**City of Portland, Maine – Building or Use Permit Application** 389 Congress Street, 04101, Tel: (207) 874-8703, FAX: 874-8716

Location of Construction: 441418 Westbrook St. 04102		Owner: Bruce L. Robinson		Phone: 874-7403	Permit No: <b>000427</b>
Owner Address: 544		Lessee/Buyer's Name: N/A		Phone: N/A	Business Name: N/A
Contractor Name: Foundation: John Warren		Address: 119 Riverside Windham, ME		Phone: 892-4886	Permit Issued: MAY 4 2000
Past Use: 1-Family		Proposed Use: 1-Family with 2-car garage.		COST OF WORK: \$ 26,000	PERMIT FEE: \$ 100.00
Proposed Project Description: 1 1/2 story wood entry way with 2-car garage with living space (for future), an 2nd floor, 3-season deck off entry balcony off 2nd flr.		FIRE DEPT. <input type="checkbox"/> Approved <input type="checkbox"/> Denied		INSPECTION: Use Group: A-3 Type: 5B DOC 999 <i>[Signature]</i>	
		Signature:		Signature:	
Permit Taken By: UB		Date Applied For: 4-26-00		PEDESTRIAN ACTIVITIES DISTRICT (P.A.D.) Action: <input type="checkbox"/> Approved <input type="checkbox"/> Approved with Conditions <input type="checkbox"/> Denied <input type="checkbox"/>

LAND USE - ZONING REPORT

BUILDING PERMIT REPORT

1618 Westbrook Street

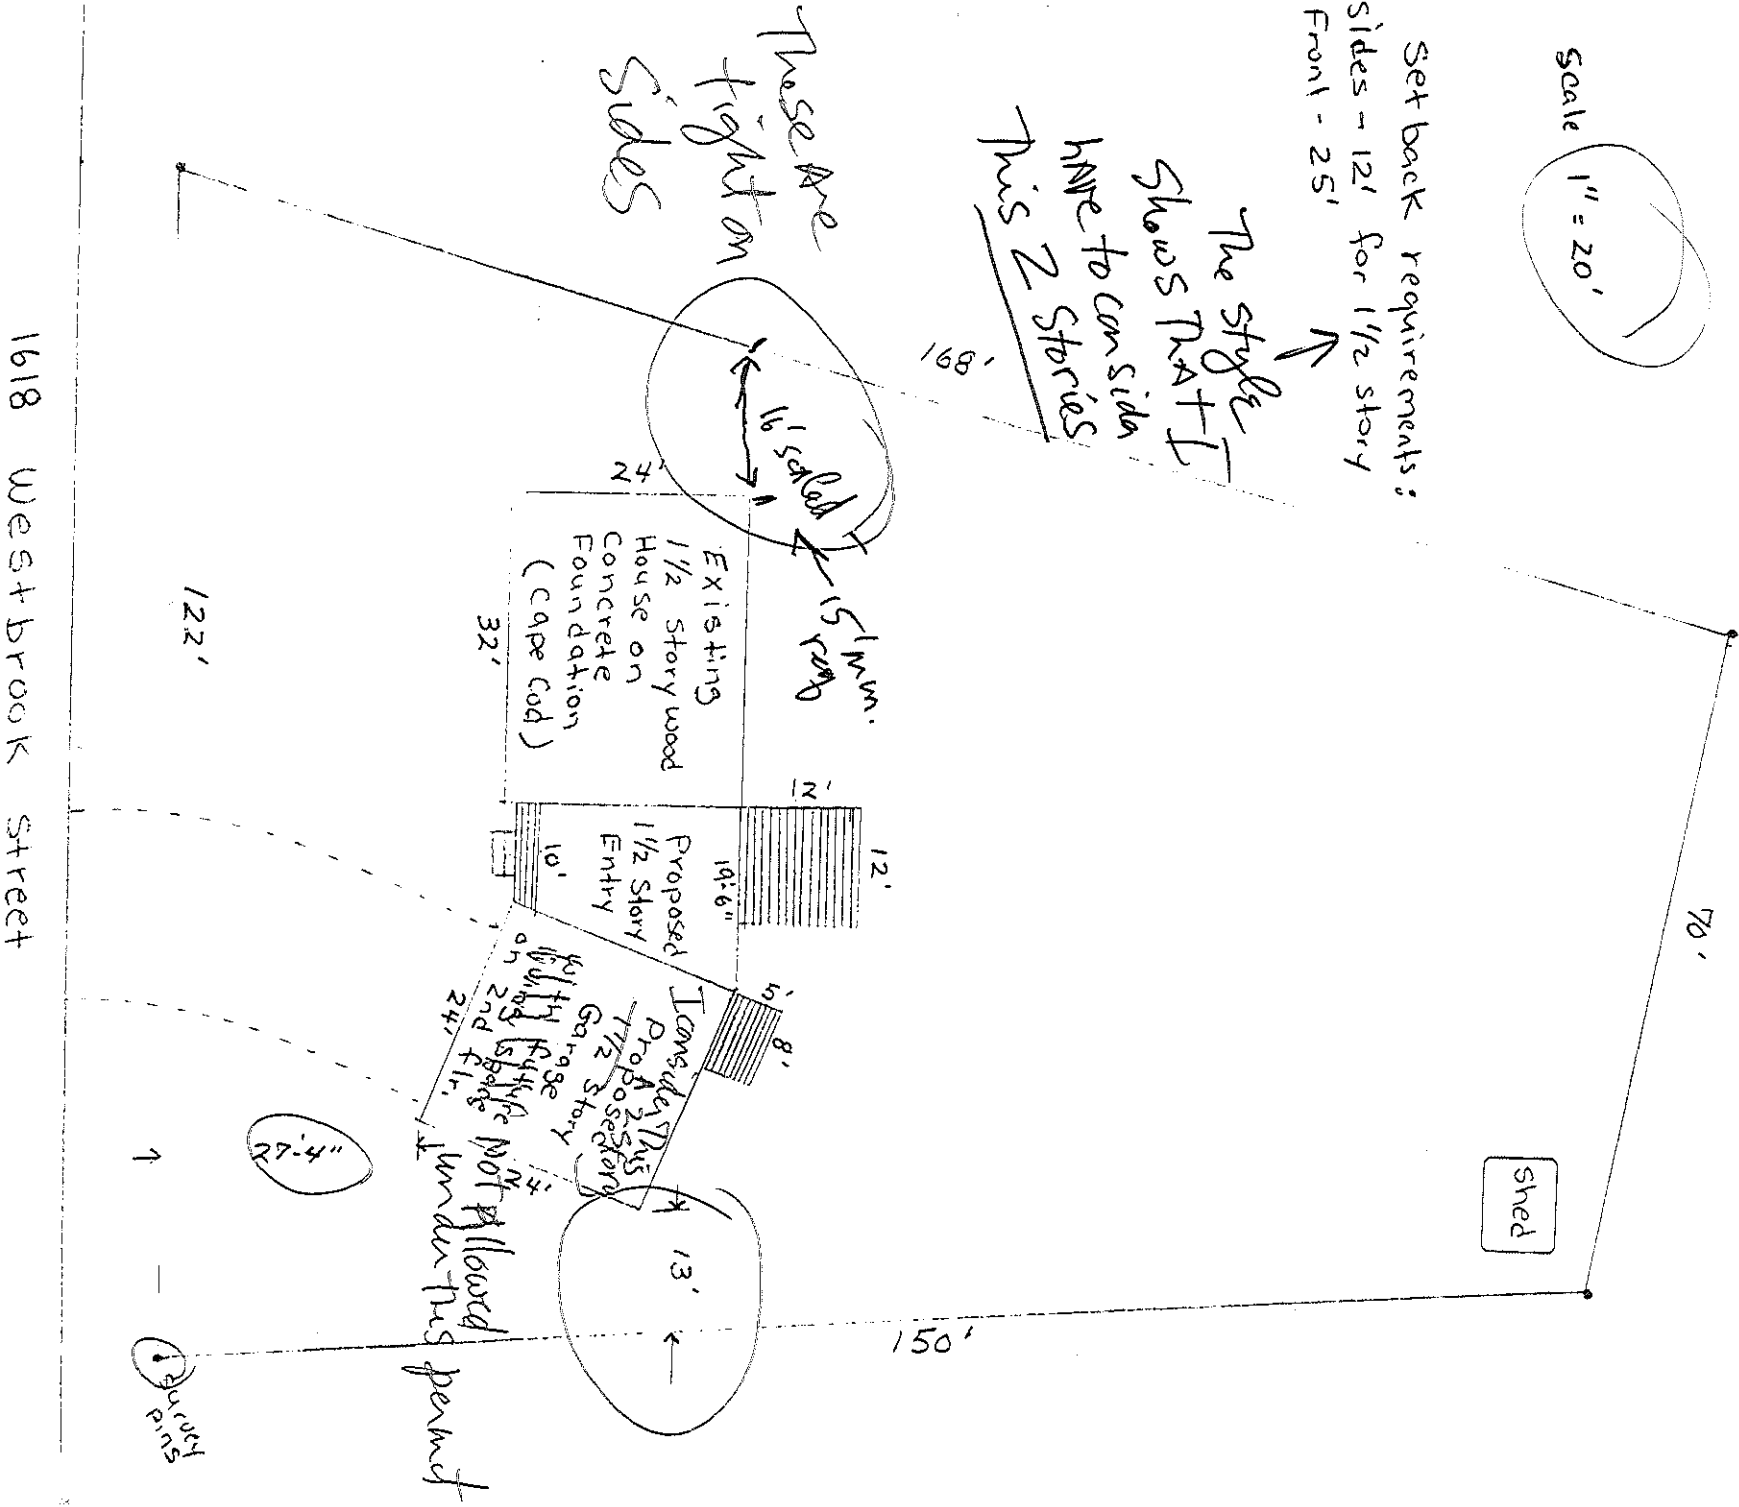
Above the garage car. No be plumbed or provide for dwelling unit above  
The garage is a separate permit is required for the area above the garage. Any unit would require zoning board approval

Setback requirements:  
 Sides - 12' for 1 1/2 story  
 Front - 25' ↓

The style shows that I have to can side this 2 stories

These are tight on sides

you attached garage is considered 2 stories not 1 1/2 stories, that requires a 14' side yard setback. you can reduce the right side 4' 13 feet AS you plans show AS LONG AS the foot taken off on one side is added on to the opposite side, therefore 15' setback would

~~be sure~~ Side Yard - 14' req - can reduce to no less than 12' but for every foot reduced from 14', 1st foot needs to be added to other side - they are showing 13' on right side, so 15' is required on left side (16' scaled as exists)
